Littleton King Street Common Phase 1 Retail Development - Peer Review

December 15, 2025

Review by Utile Architecture and Planning

Option 2: Reduce the width of the garage

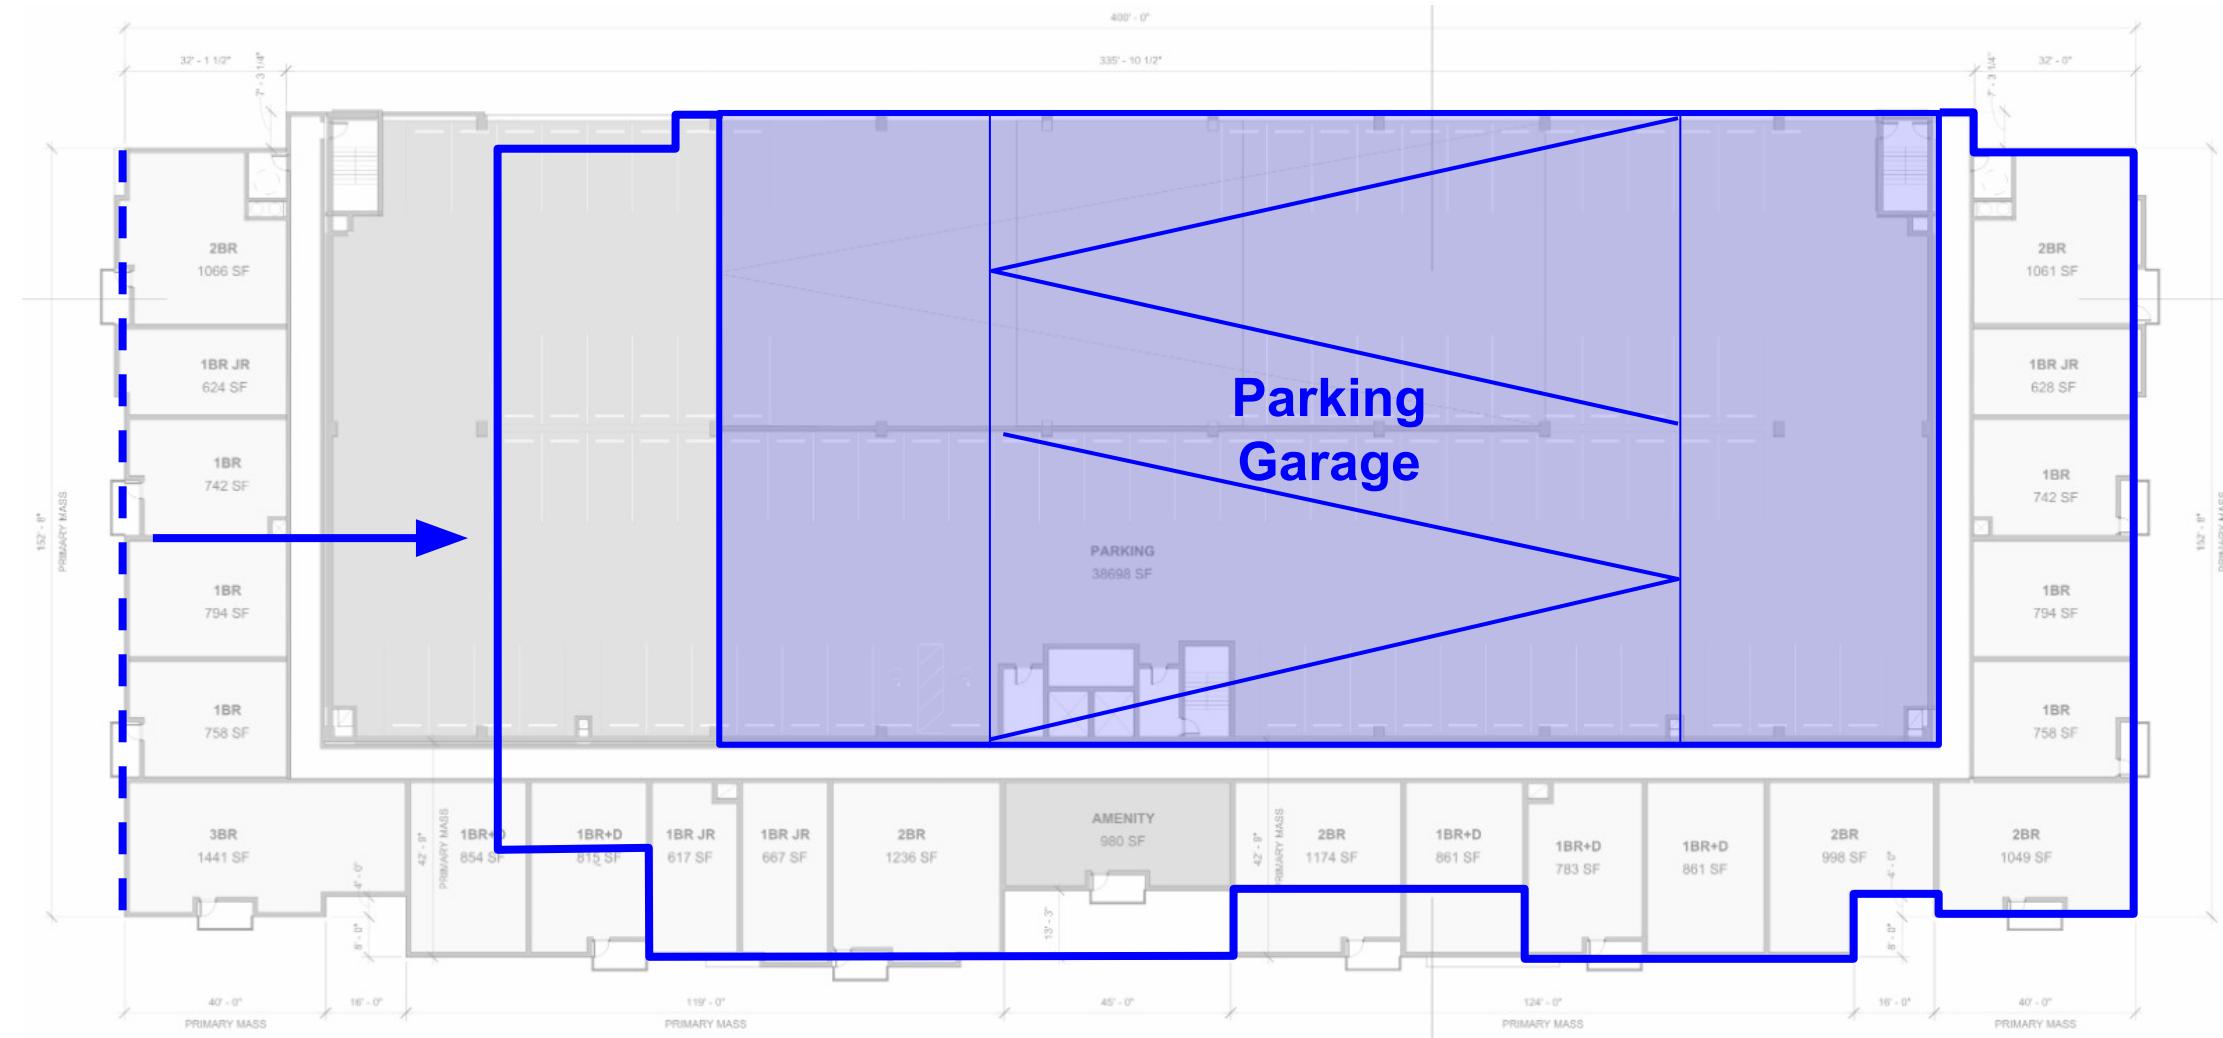
An alternate option is to reduce the width of the garage (while keeping the height) such that it is just enough to accommodate the minimum ~344 spaces. This would likely require switchback sloped parking ramps (vs ramp on only one side/bay).

Importantly, this would reduce the width of the whole building (making it more contextual in scale), and the gained open space can be added public space, a surface parking lot, or a another 1-story commercial building.

Proposed assembly plan
(east half of building)

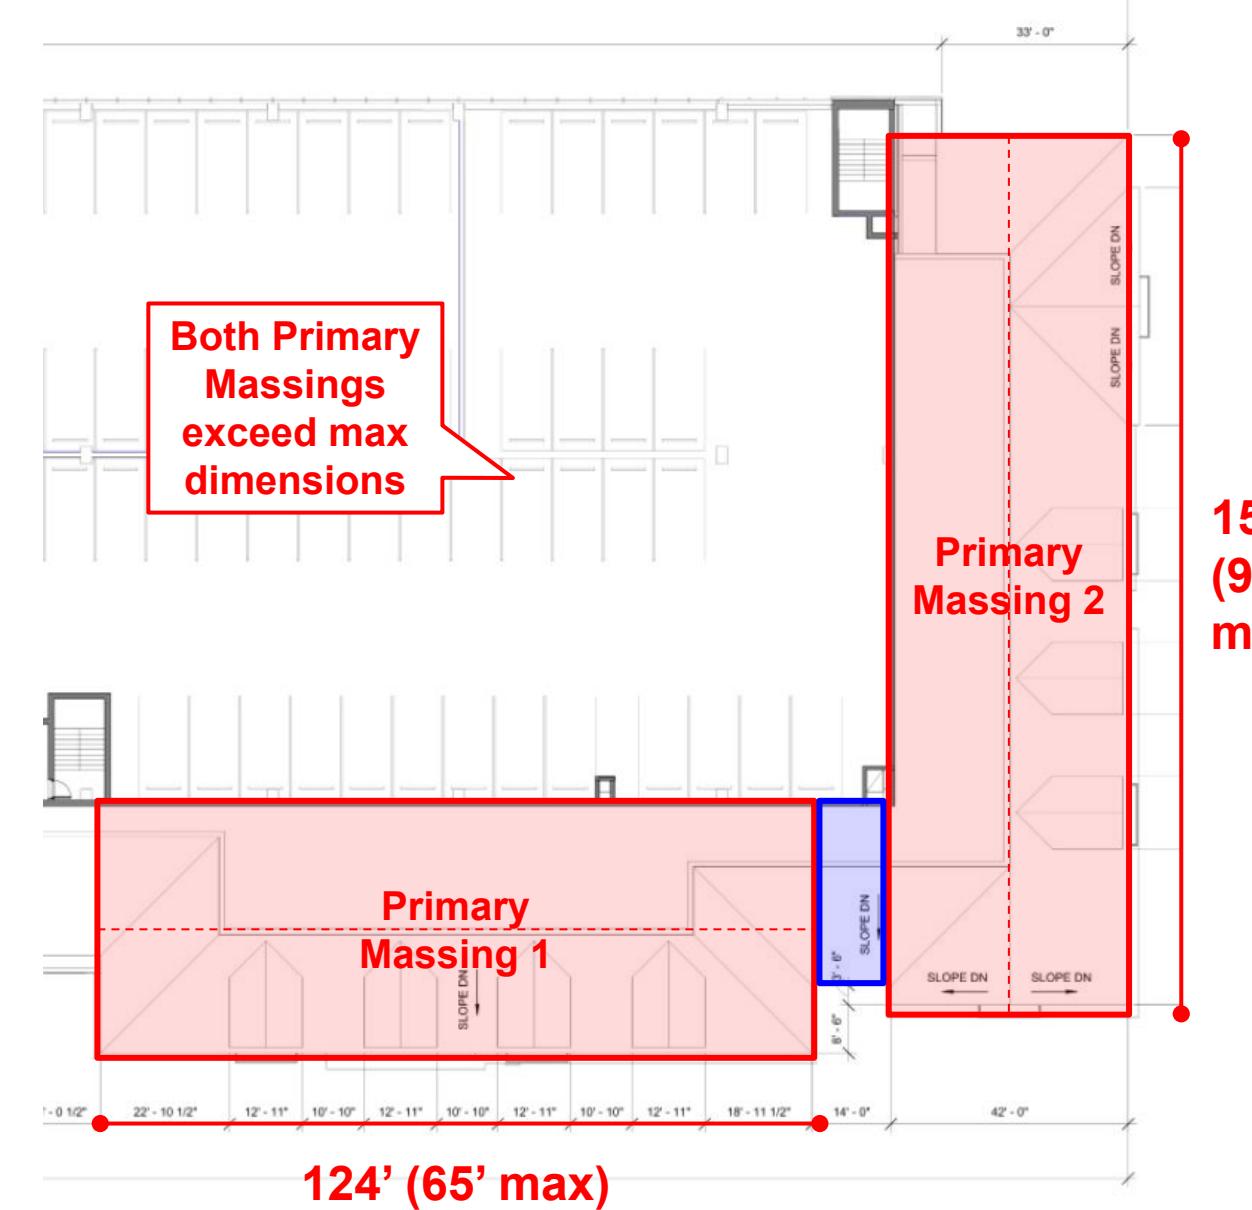
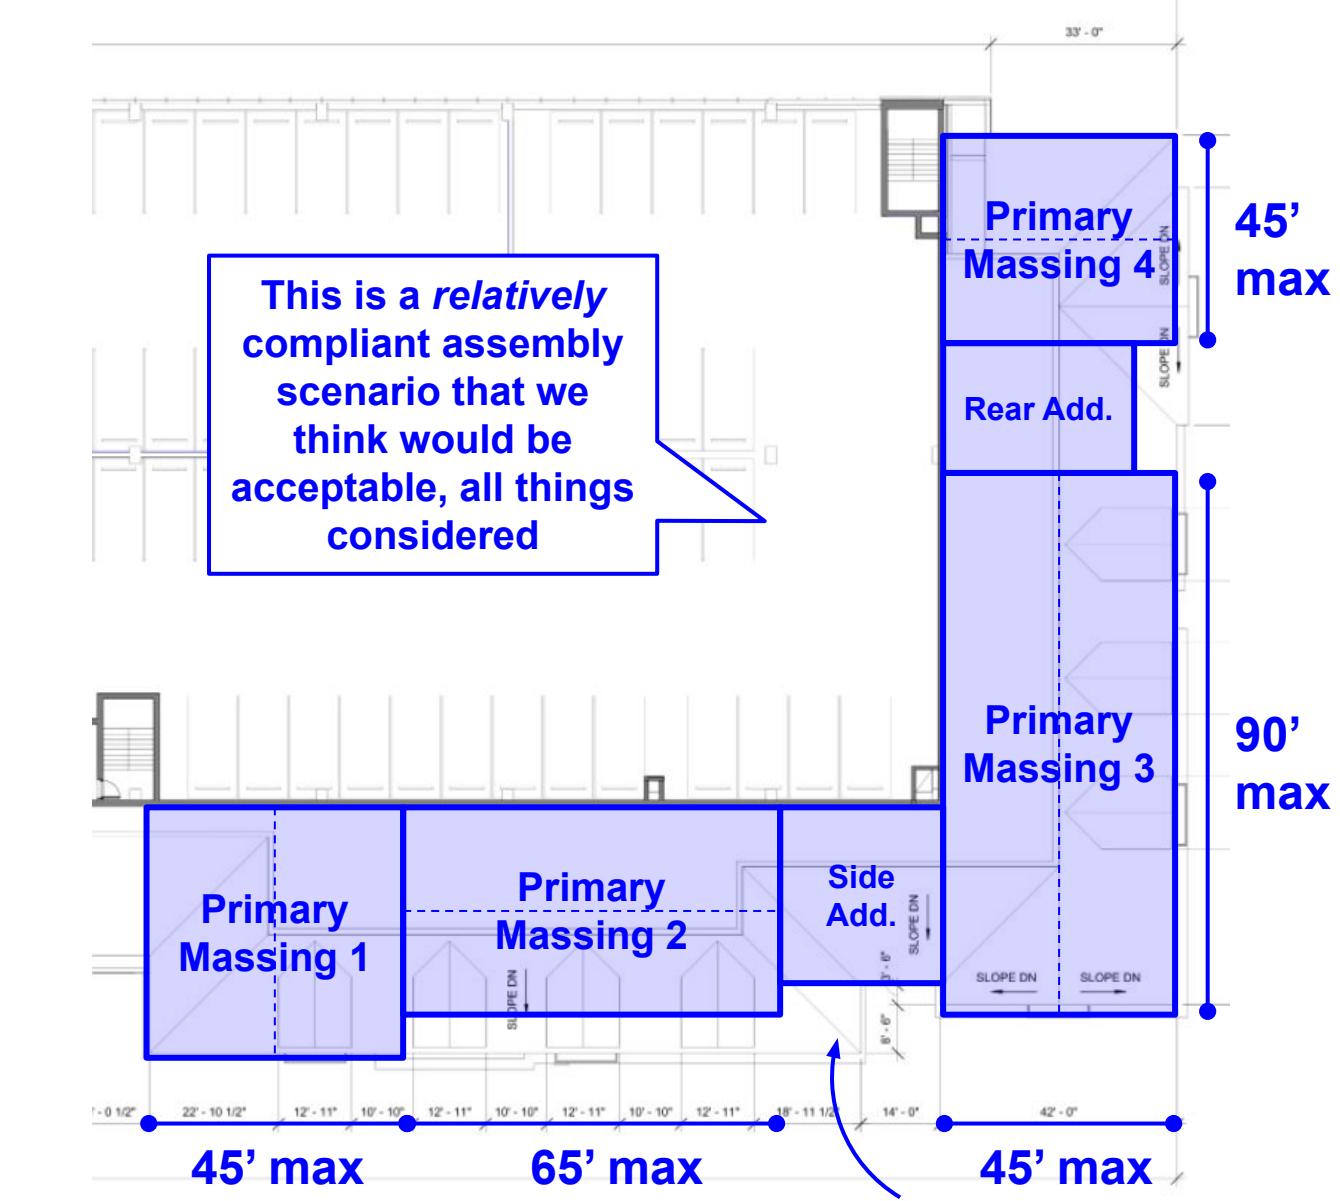
In addition to Comments #1 and #2, ensure that the program wrapping the garage also complies with the primary massing maximums as set in the VC FBC (similar to the comments for Buildings 1100, 1200, 1400, and 1500).

Currently, the widths and depths of the primary massing *almost double* the allowed respective maximums (e.g., a width of 124 ft vs 65 ft max), resulting in a substantially oversized building. See example at right for how to bring a portion of the building into (relative) compliance. ([§173-221.K. General Building Standards Primary Massing](#))

Example Revised Site Plan Based on Most Building Comments Above

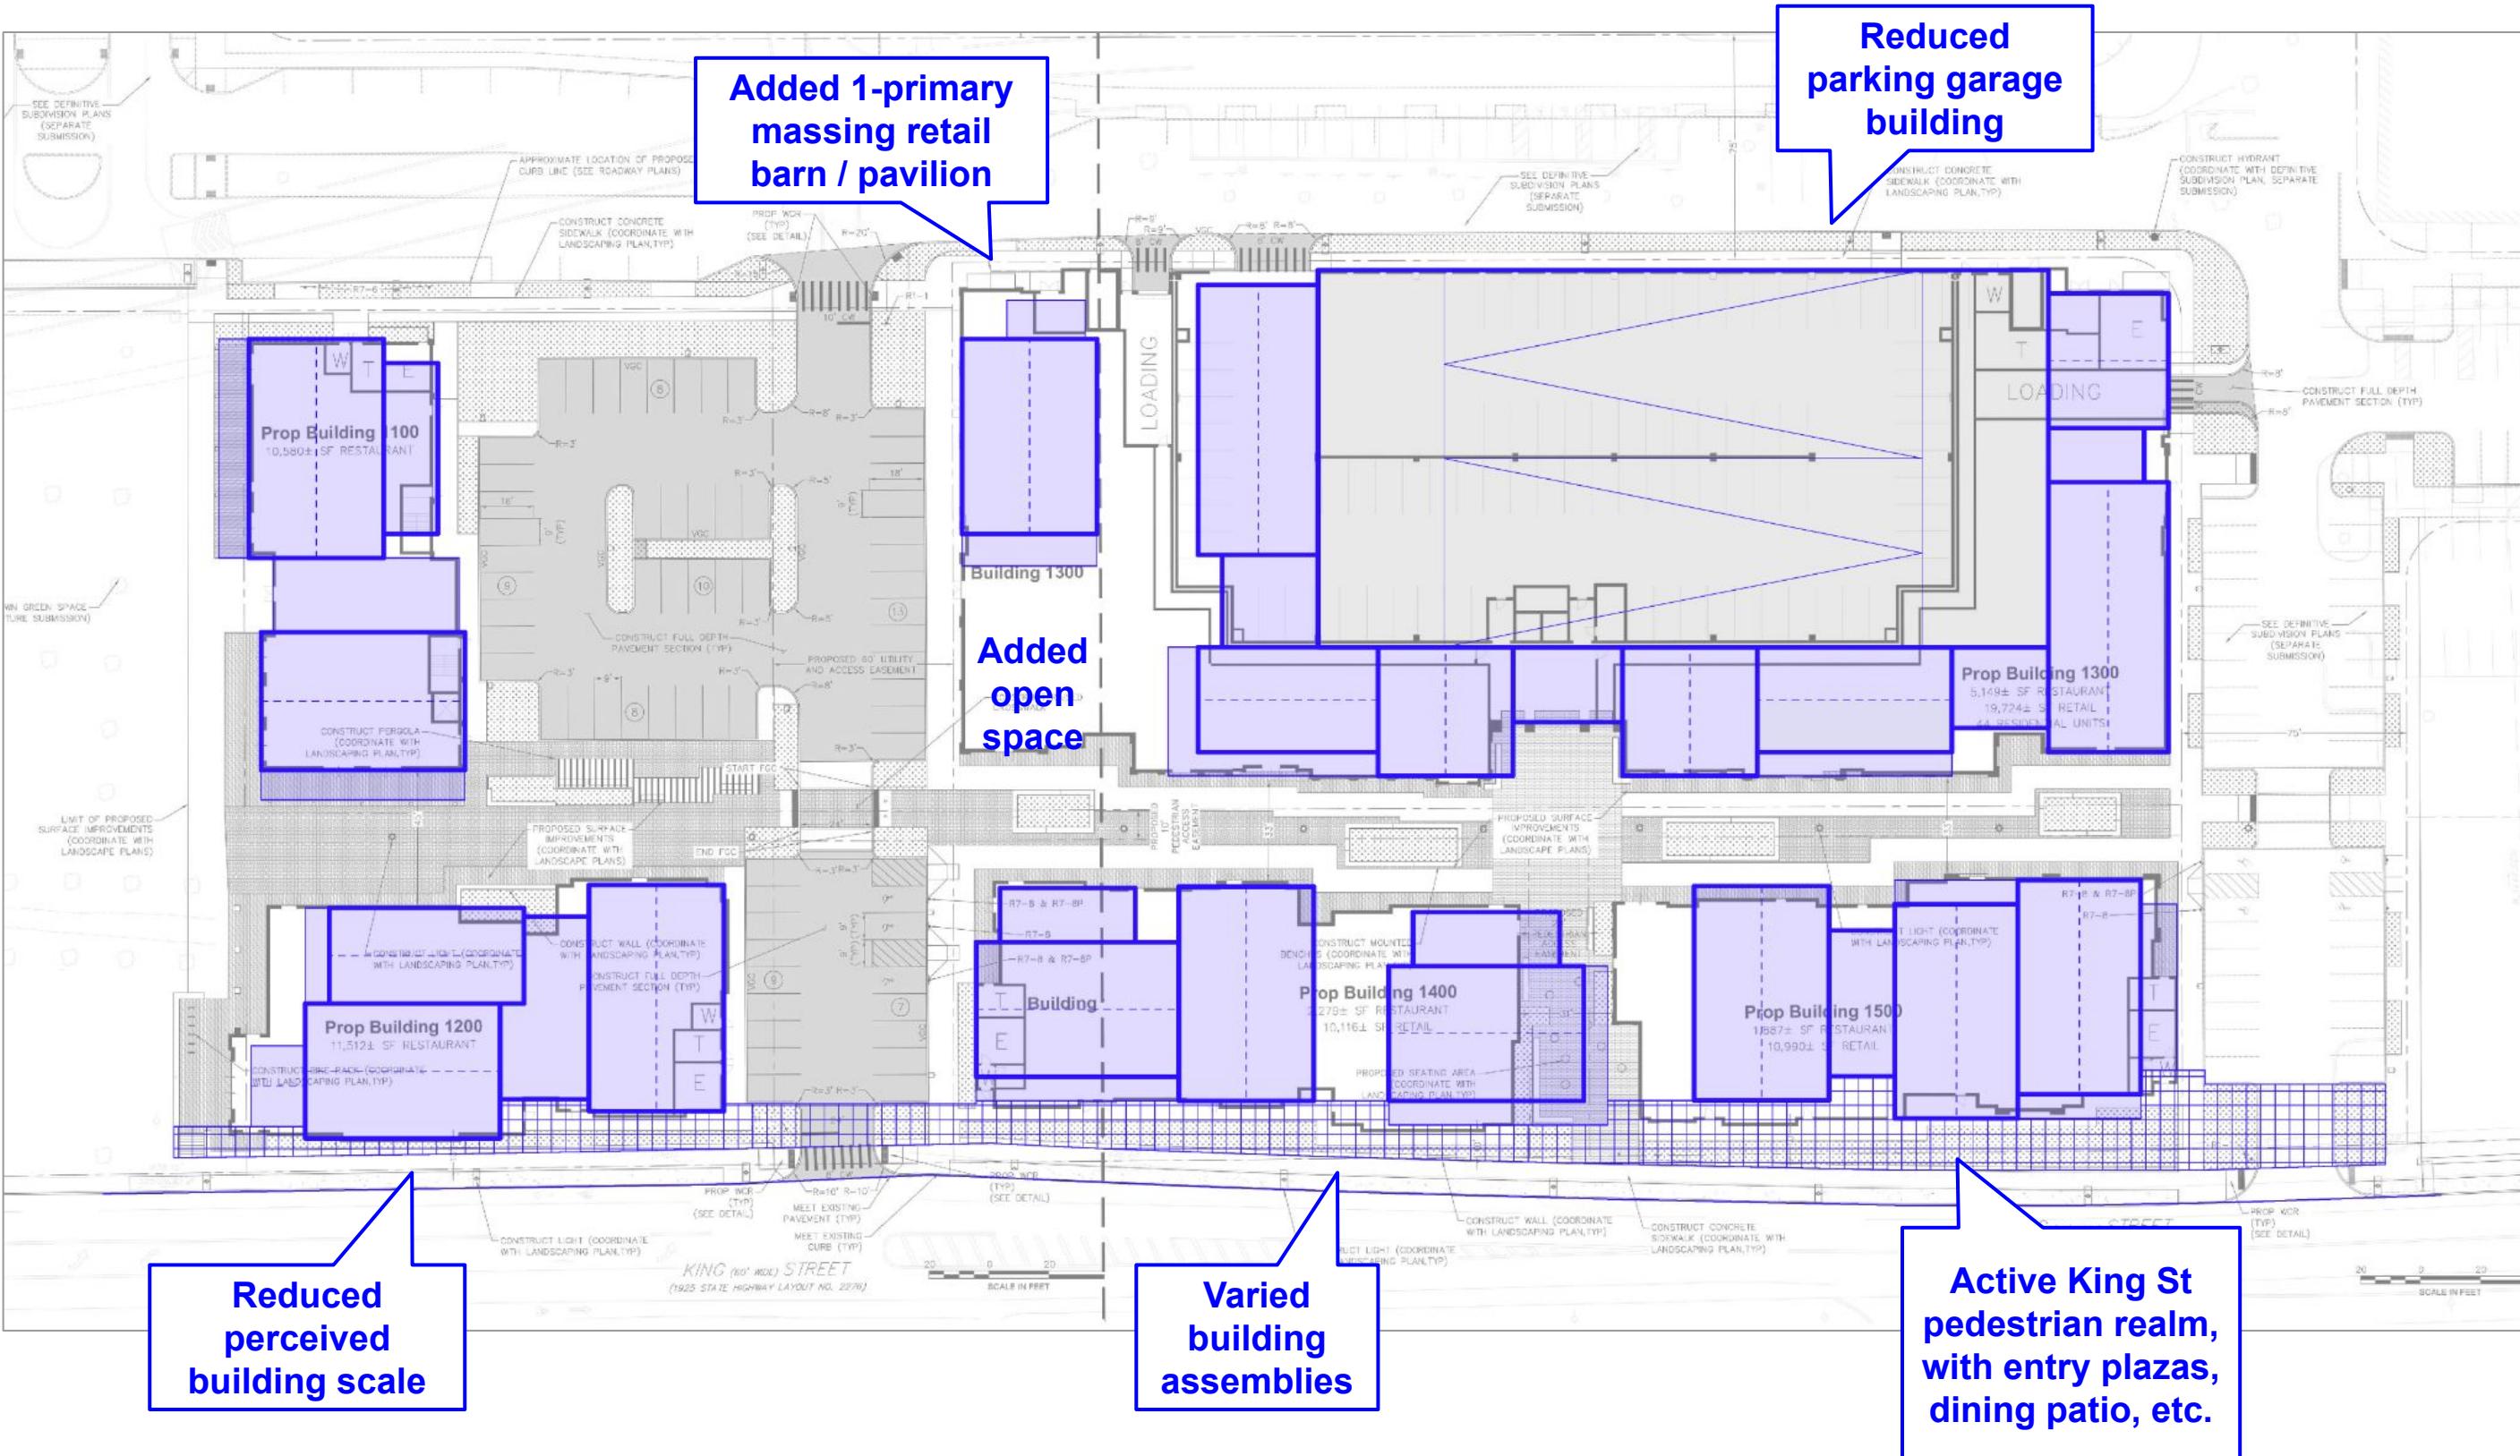
This is a hypothetical example site plan updated to reflect most of the building comments above, showing:

- Varied building assemblies (i.e., 1-, 2-, and 3-primary-massing assemblies)
- Primary massings (and building components) that are within the max dimensions
- Reduced wrapped-garage building (in this case reduction in width)
- Site comment: frontage area along King St shows an active and walkable public realm
